ADDENDUM NO. 2
TO THE CONTRACT DOCUMENTS
FOR THE CONSTRUCTION OF THE
VERNON HILLS NCT WRF PHASE 2 – 2017 IMPROVEMENTS
LAKE COUNTY PUBLIC WORKS DEPARTMENT
VERNON HILLS, ILLINOIS
BID NUMBER #17013

DATE: April 12, 2017

AT GRADE EQUIPMENT PAD

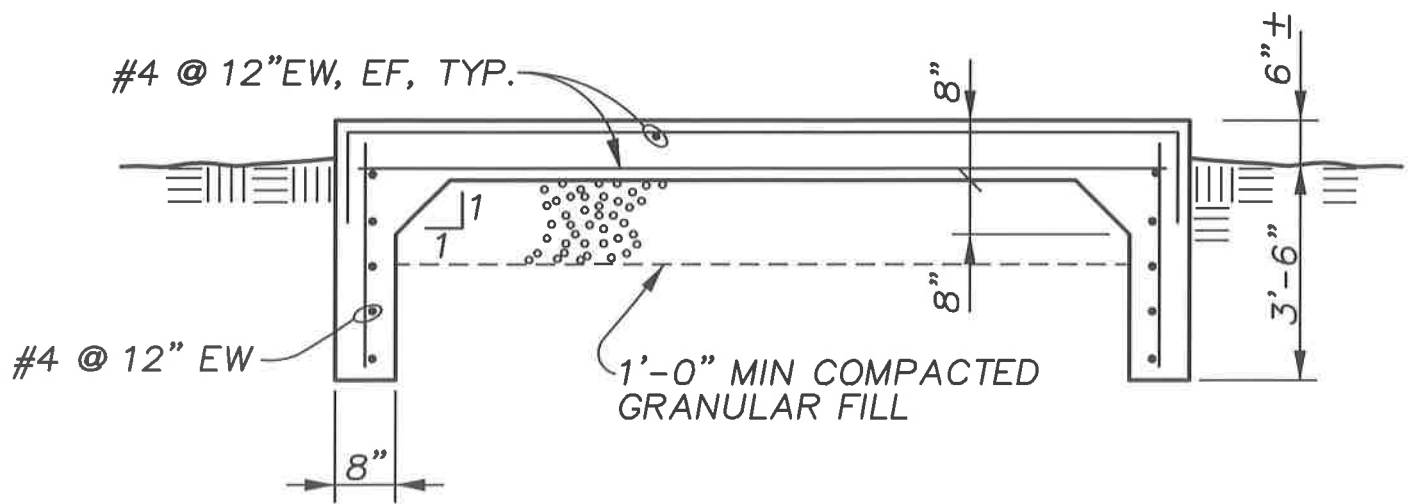
1. Add the following Plan Note below note number 2.
 3. *PROVIDE CONCRETE MOUNTING PAD FOR MANUAL TRANSFER SWITCH MOUNTING, SEE (03622) NOTE CENTER CAN BE CONCRETE VERSUS FILL AS SHOWN.*

1. Add the following Plan Note below note number 3.
 4. *PROVIDE CONCRETE MOUNTING PAD FOR TAP BOX MOUNTING, SEE (03622) NOTE CENTER CAN BE CONCRETE VERSUS FILL AS SHOWN.*

1. Add attached standard detail 03622 to the drawing.
2. Revise Roof Drain Detail 07502 by adding the following note to the drain line *“EXST DRAIN PIPING”*.
3. Revise Roof Drain Detail 07502 by adding the following notes to the detail.
